ADDENDUM NO. 1

April 1, 2022

**PROJECT: Jerome Elementary School
Jerome School District
Jerome, Idaho**

Date: 04/01/2022
Revisions: Description Addendum #1
DRAWN BY: CP
CHECKED BY: JB
BID SET
DRAWING NO.:
SL7.1
IRRIGATION PLAN- AREA ONE

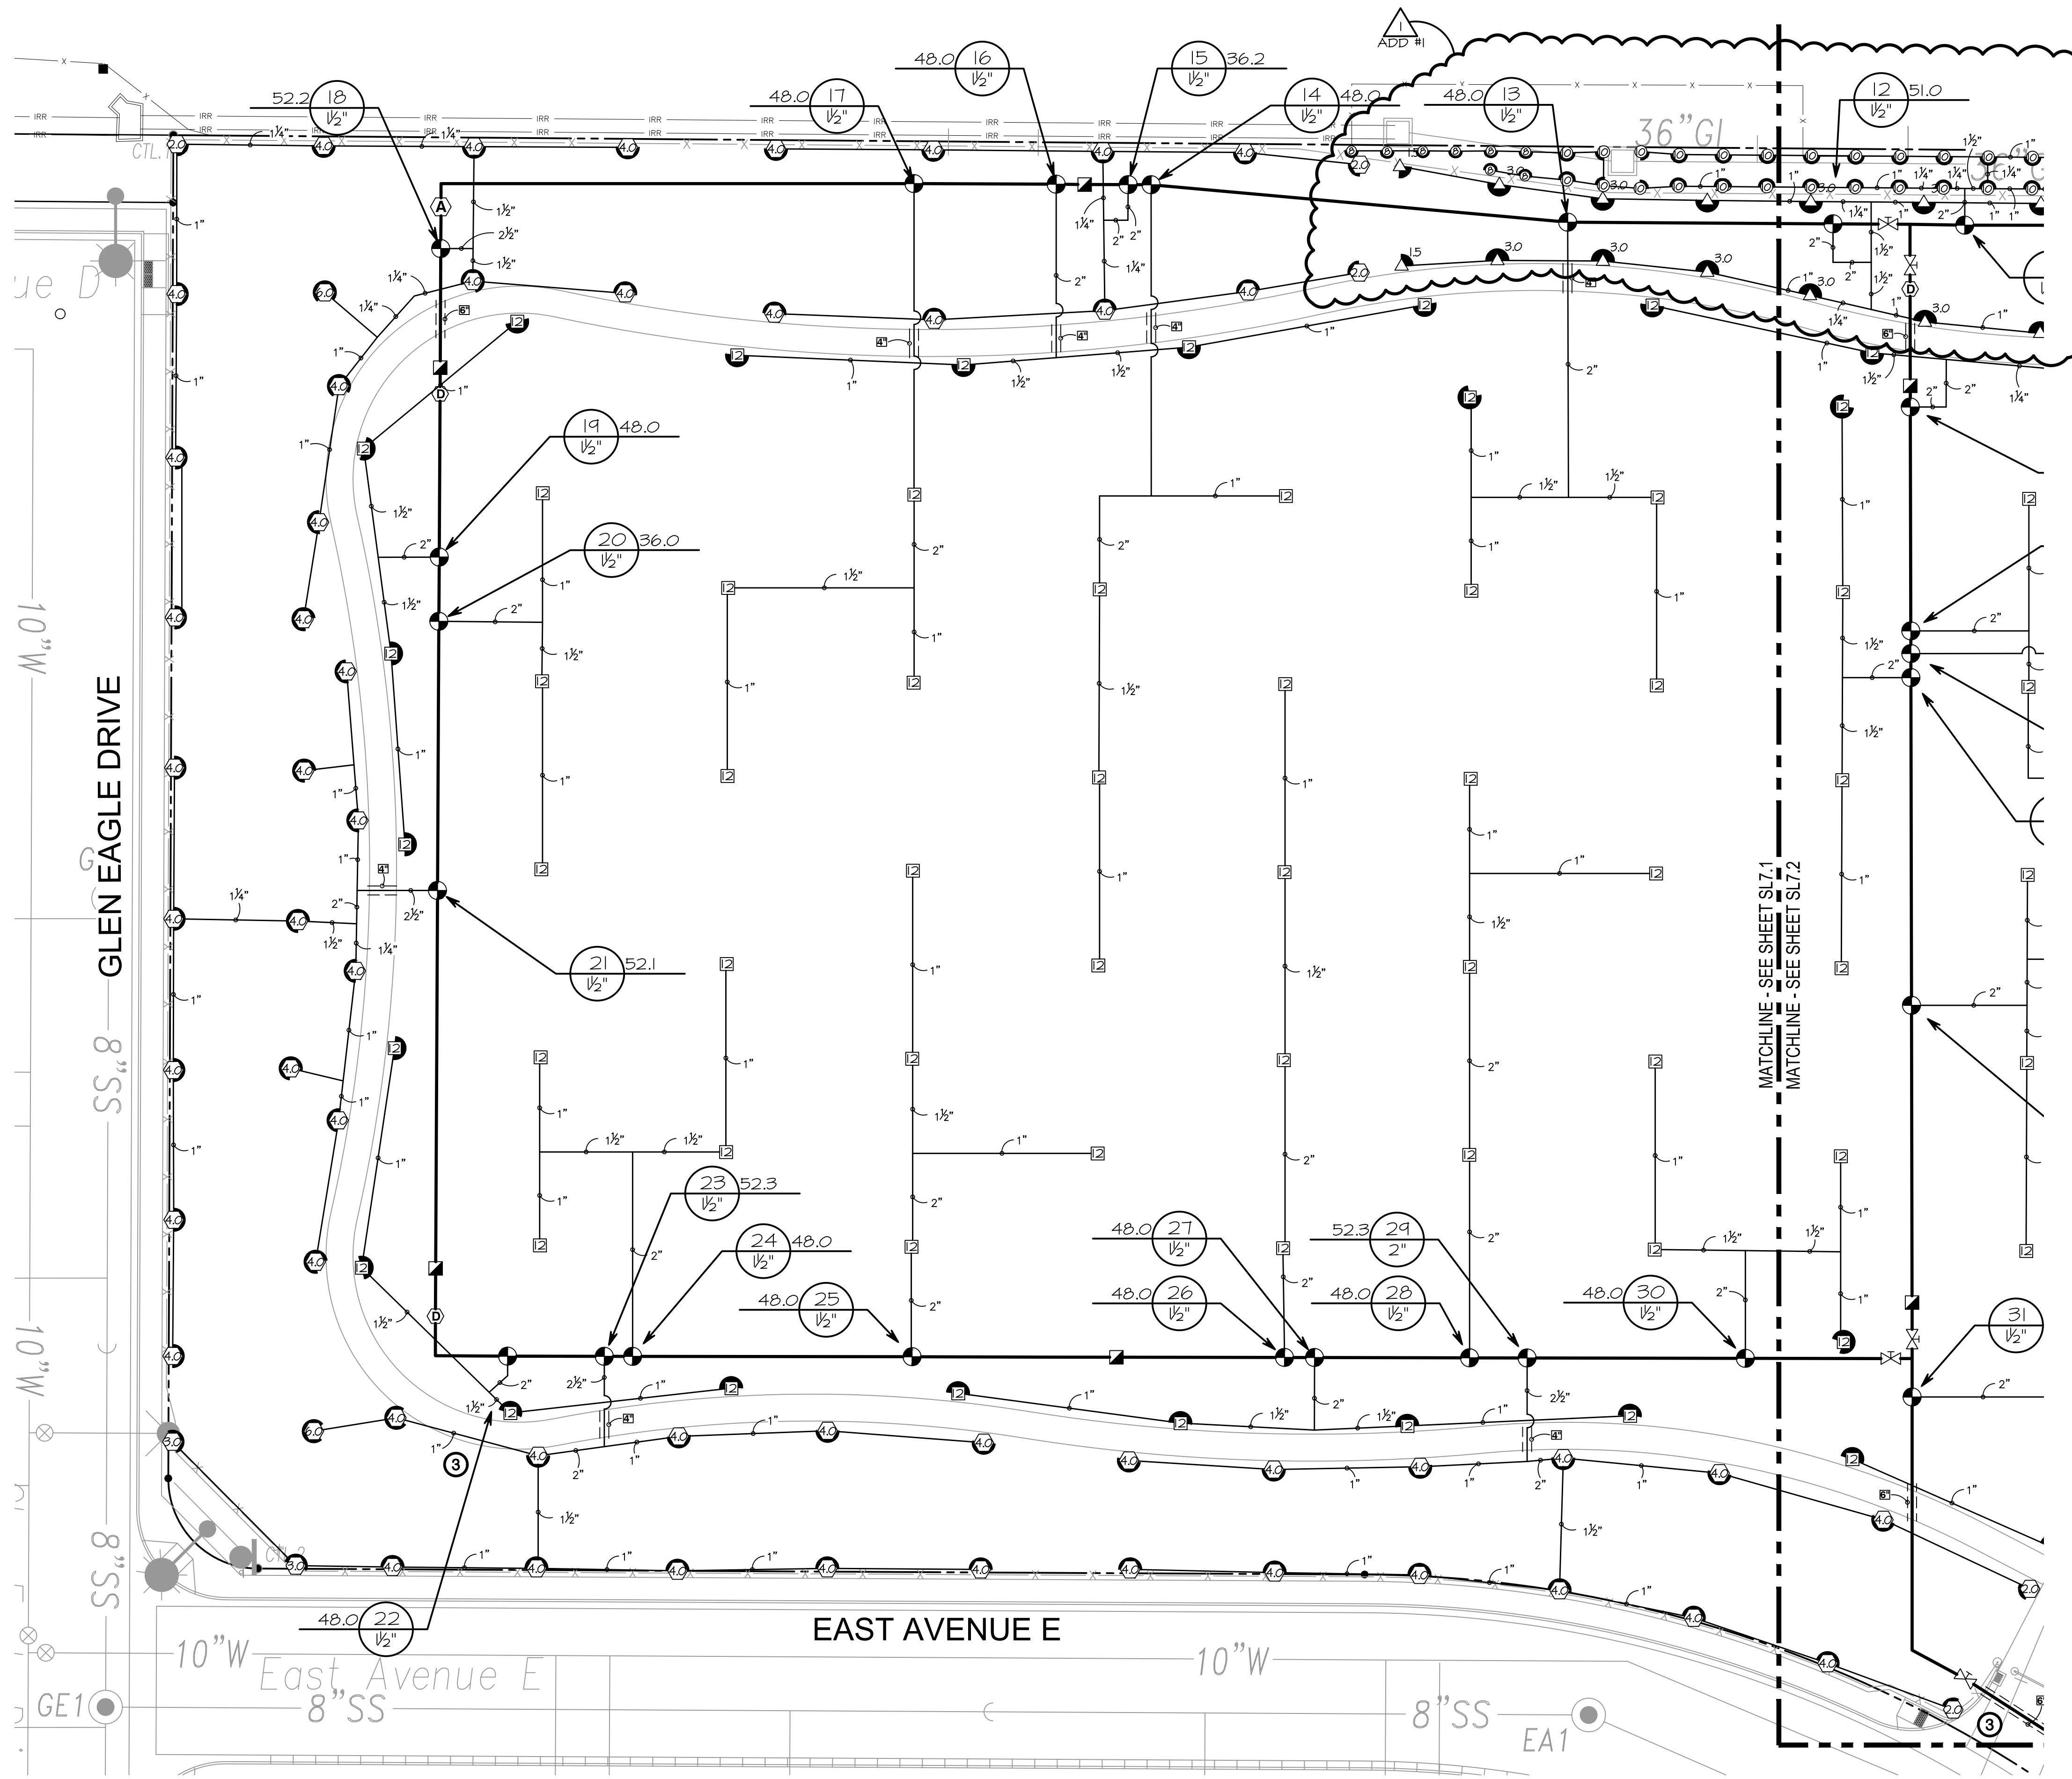
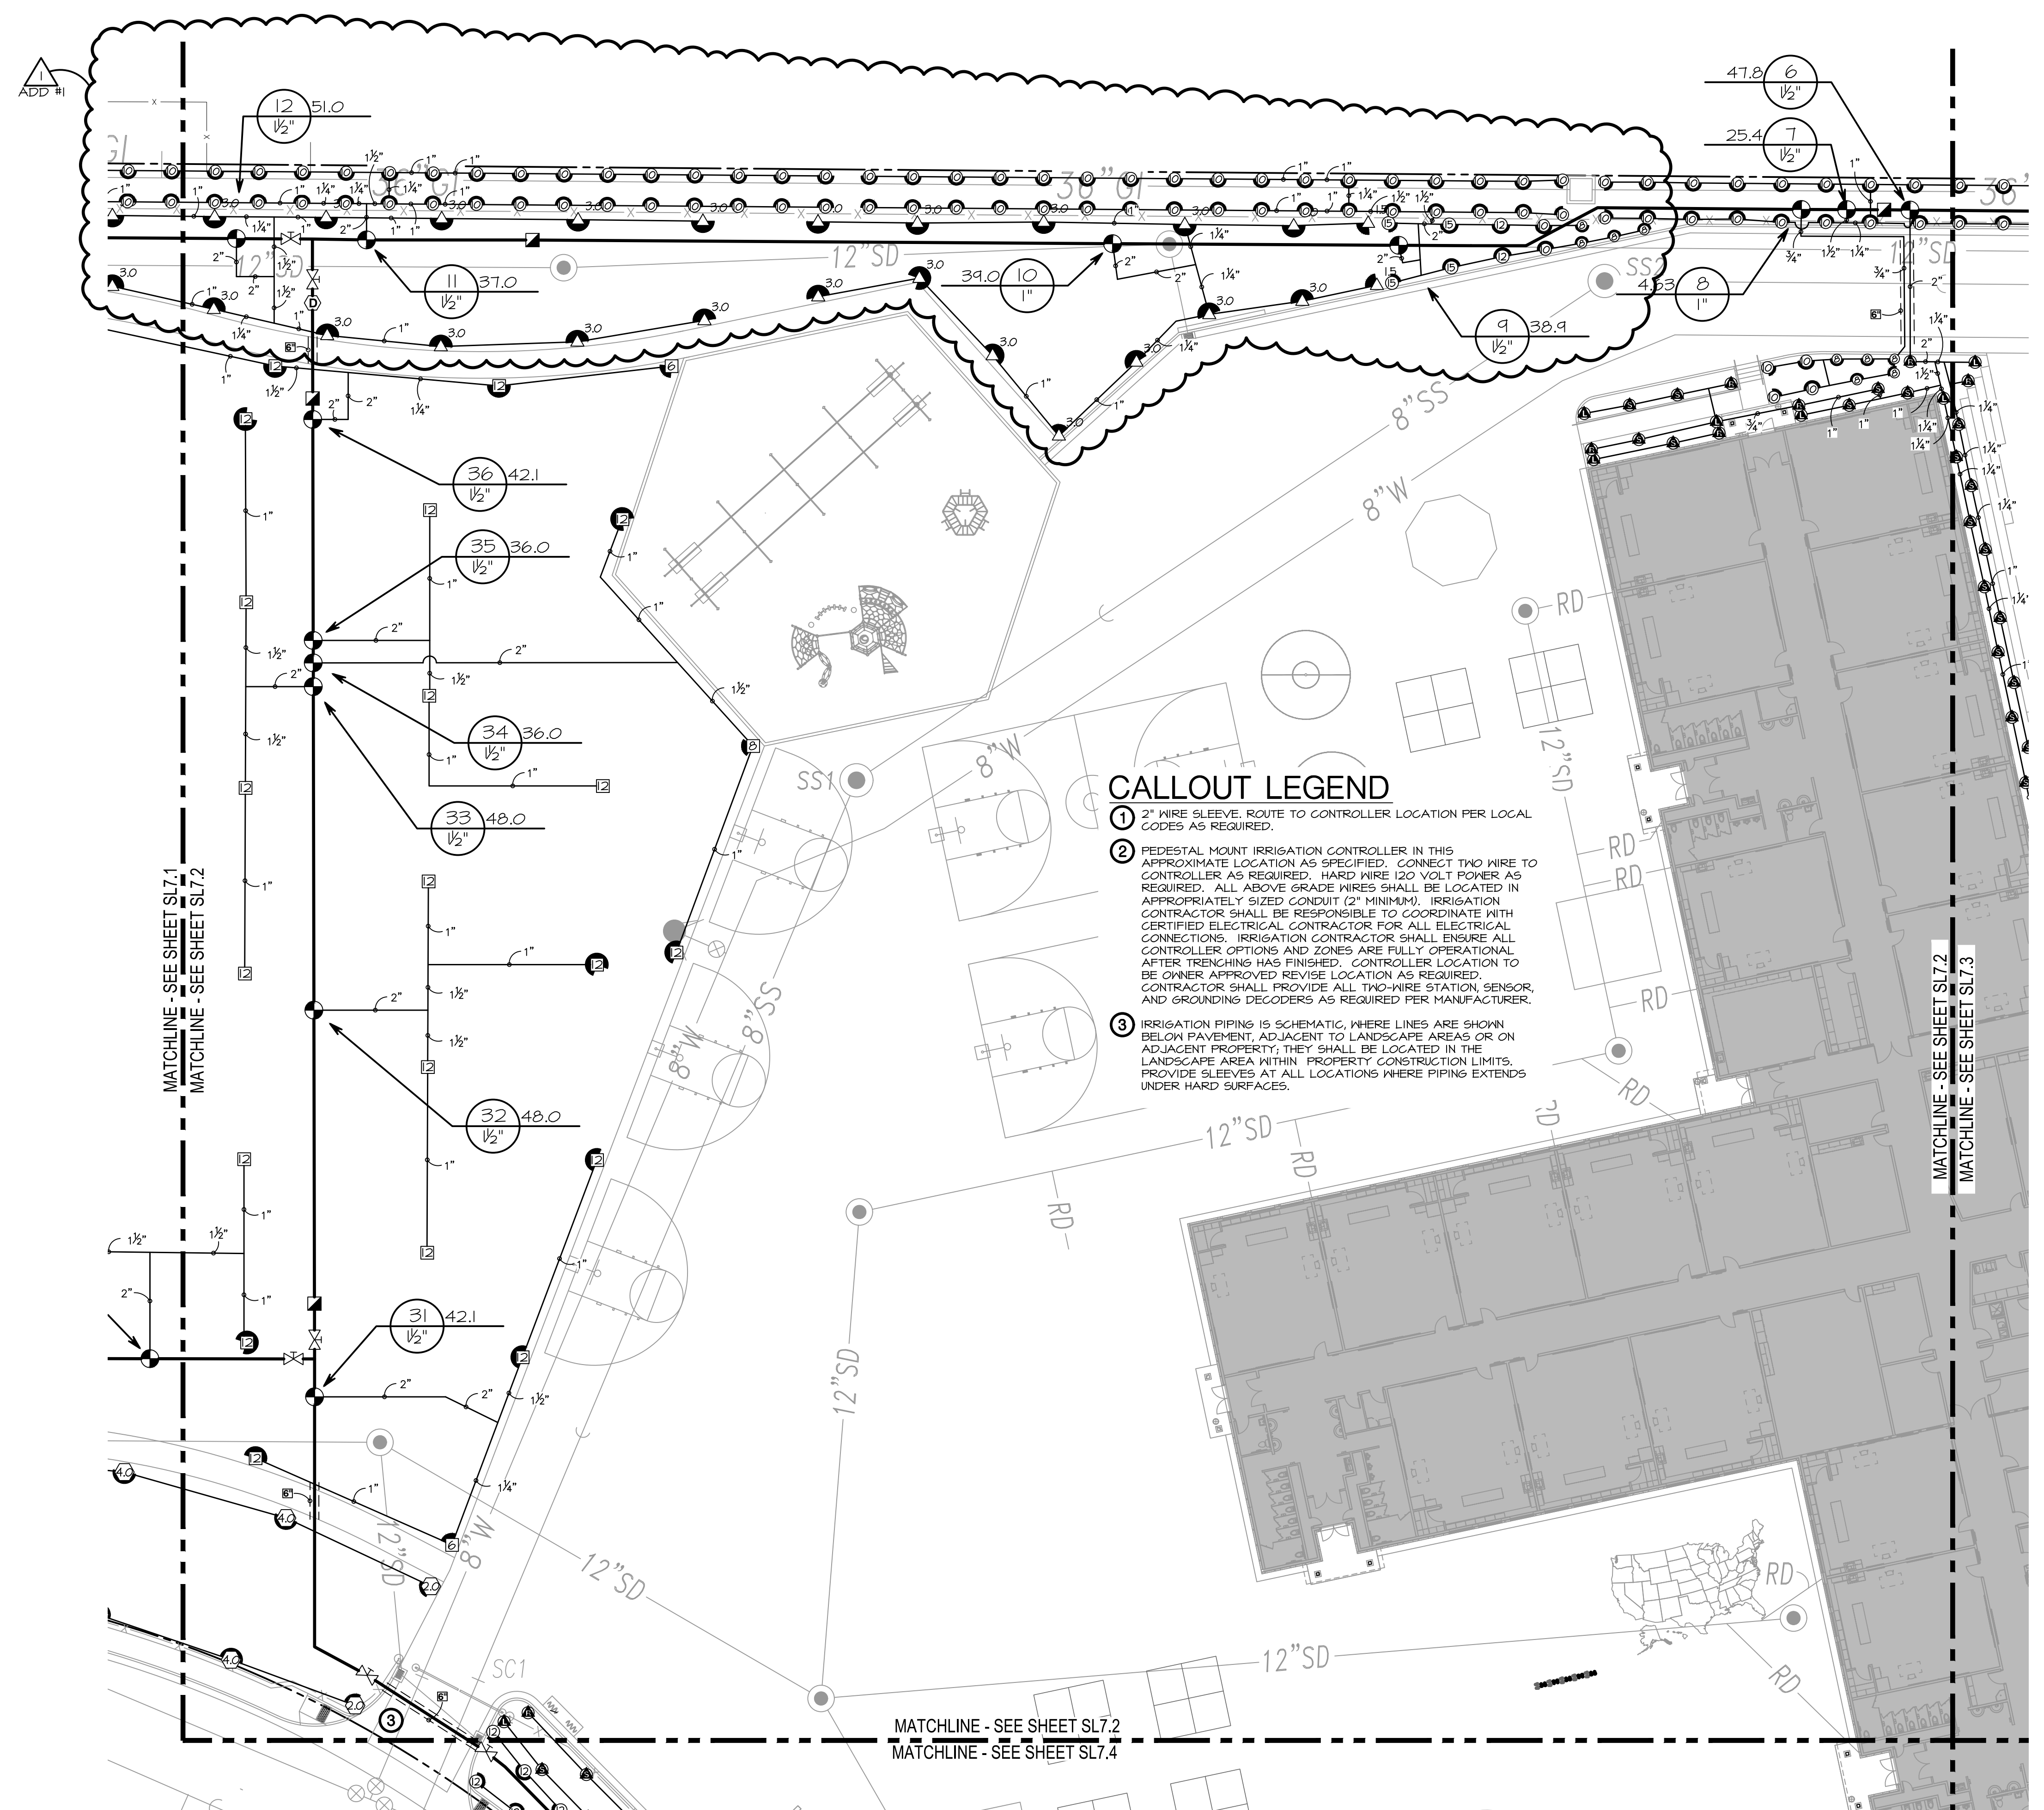
- 1-1 Replace sheets SL7.1 and SL7.2 with the attached drawings to modify irrigation layout adjacent to the north property line.

1 FLOOR PLAN - CODE PLAN
1" = 20'-0"

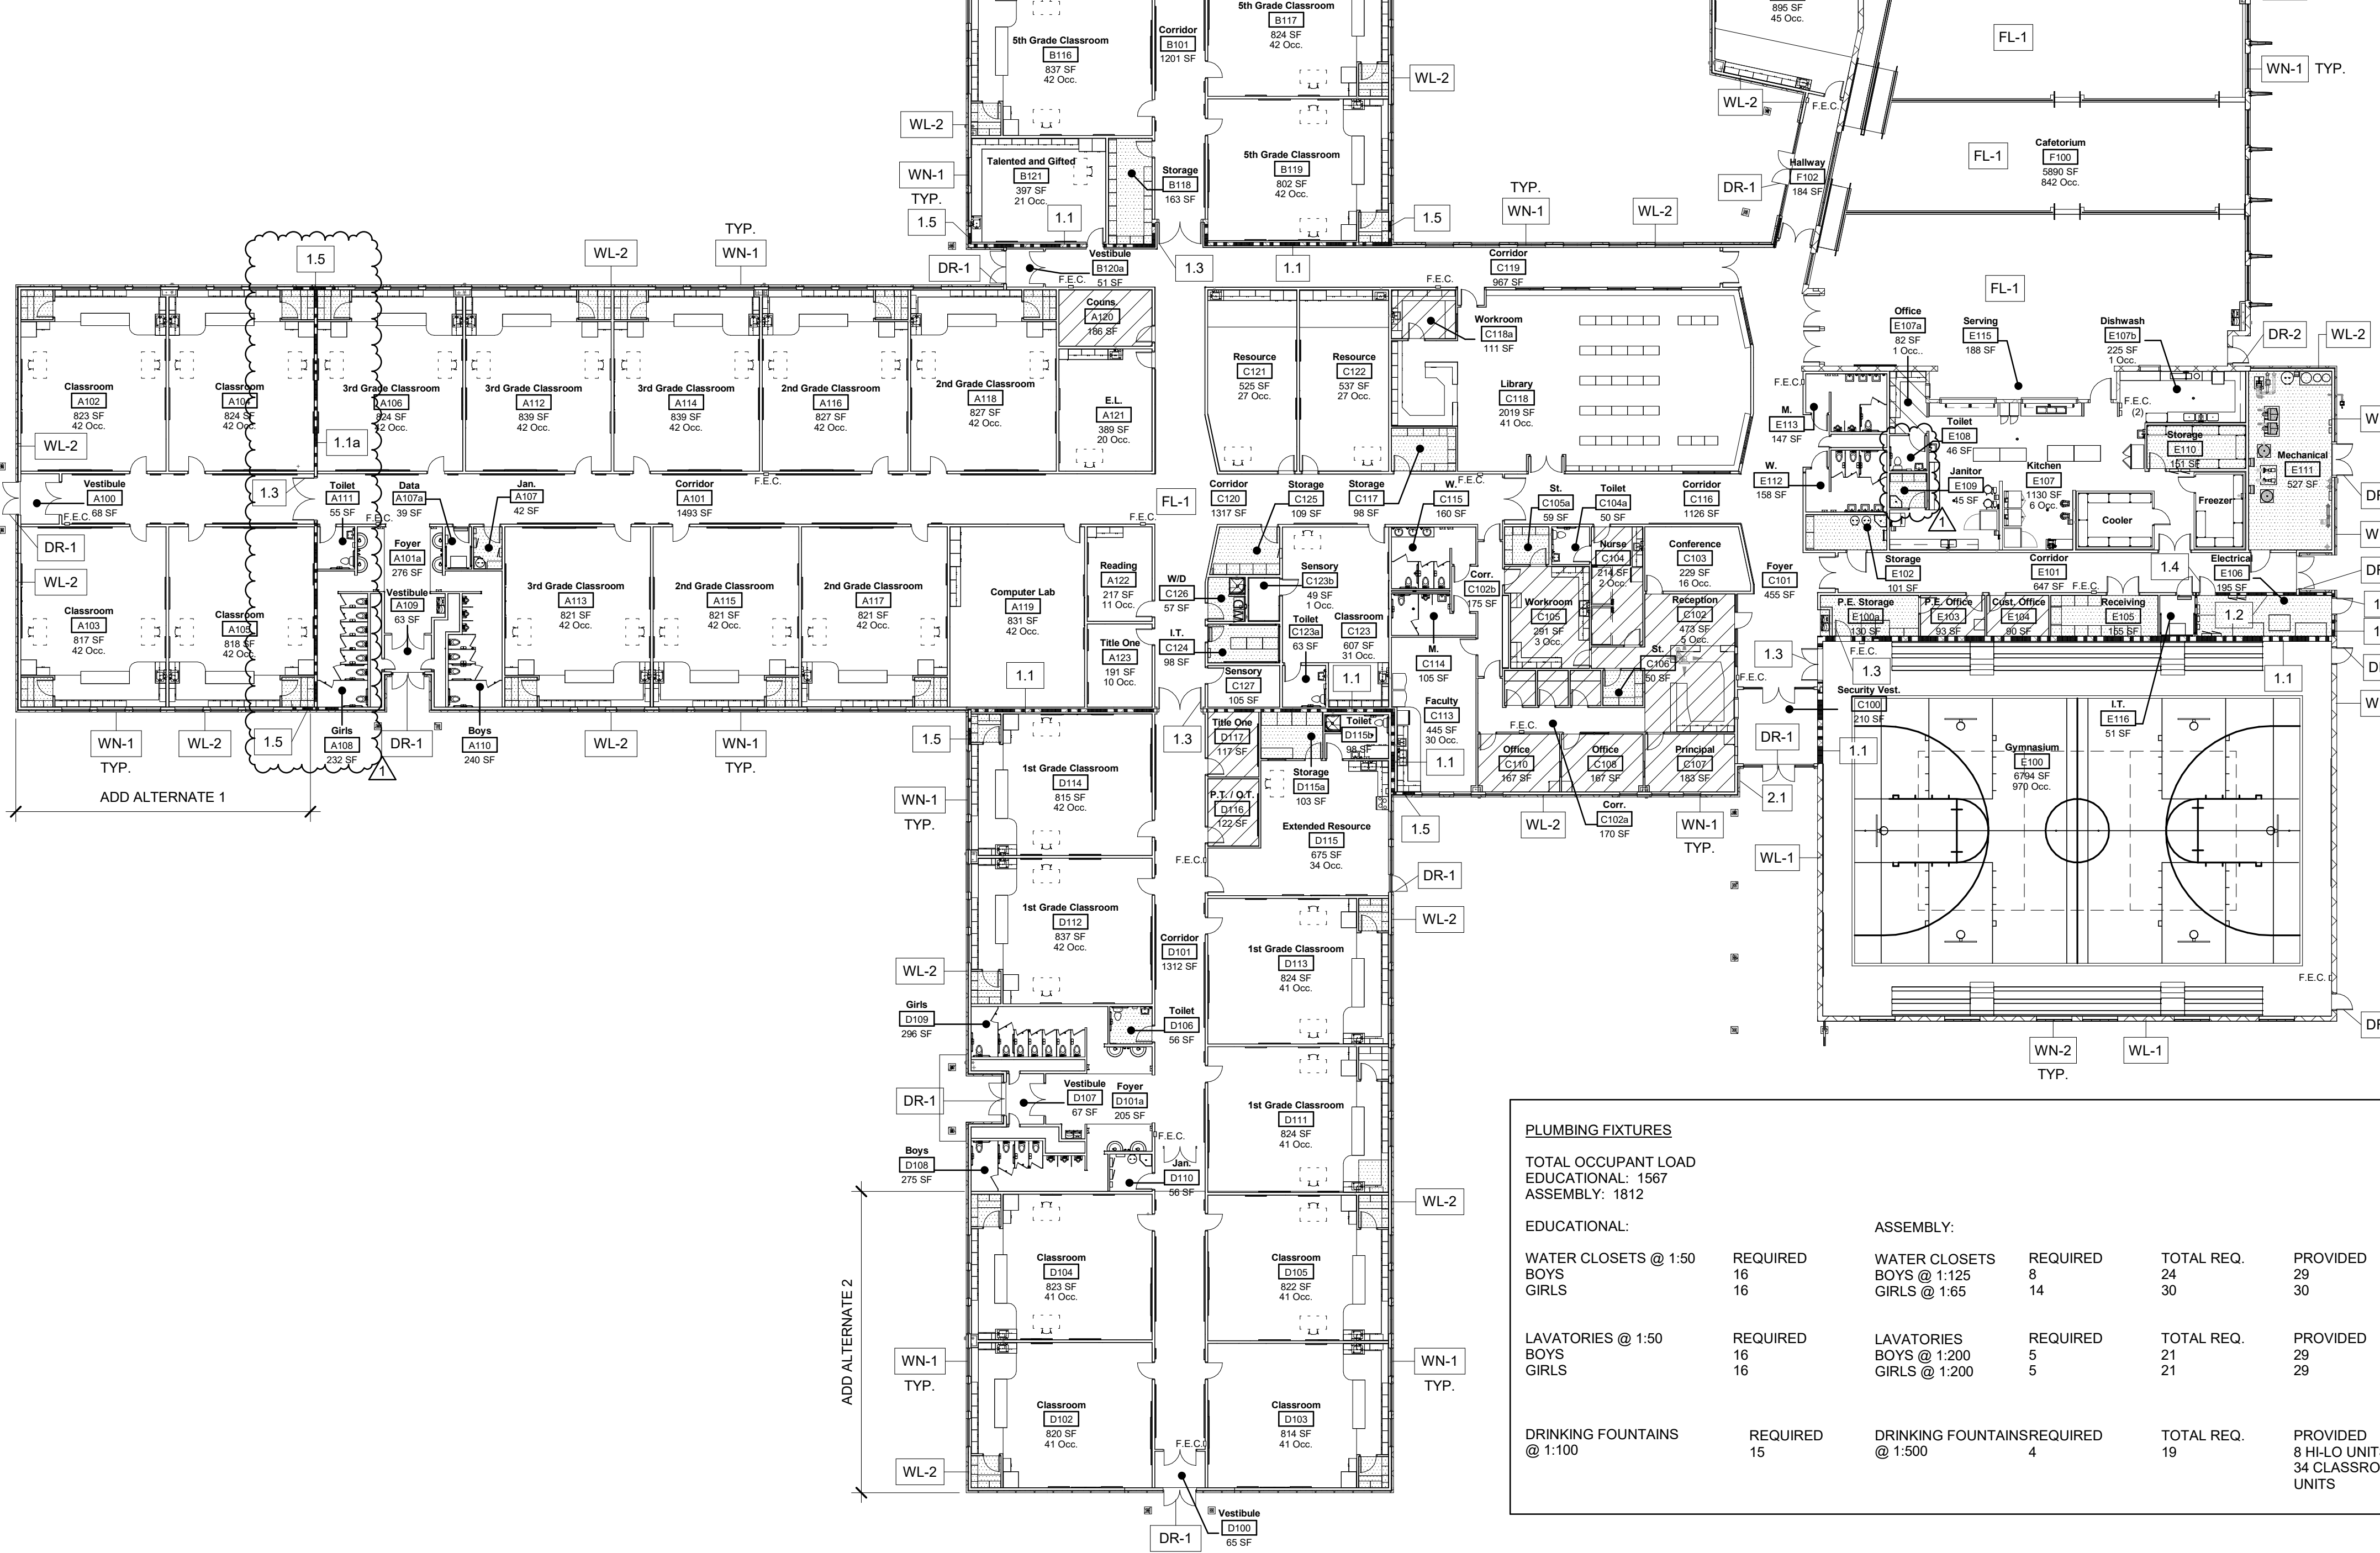
1. Revise allowable area calculations and provide new fire wall location as shown per revised Sheet A1.1, attached.
